Date: November 5, 2014
To: All Prime Bidders
RE: Eugene School District 4j
Adams Elementary School – Restroom Addition
C.I.P. No. 420.104.100

ADDENDUM #1:

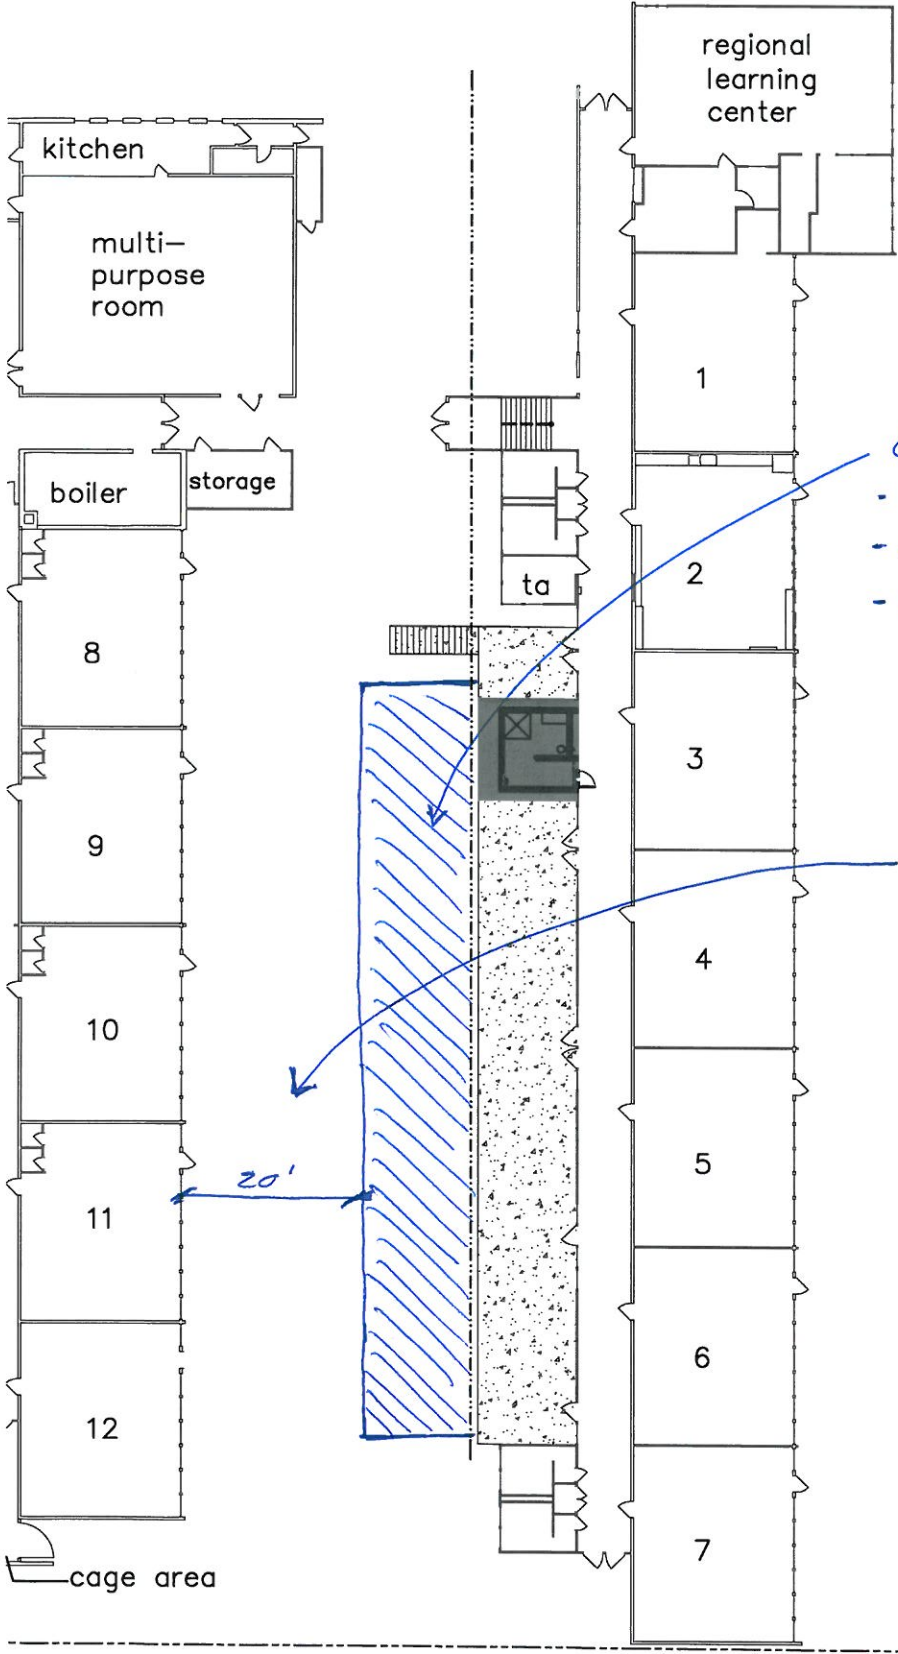
- Item #5: Please see the attached original site plan showing the location of the existing sanitary sewer line location.
- Item #6: The contractor shall assume that the existing concrete slab to be demolished has #4 rebar at 24” o.c.
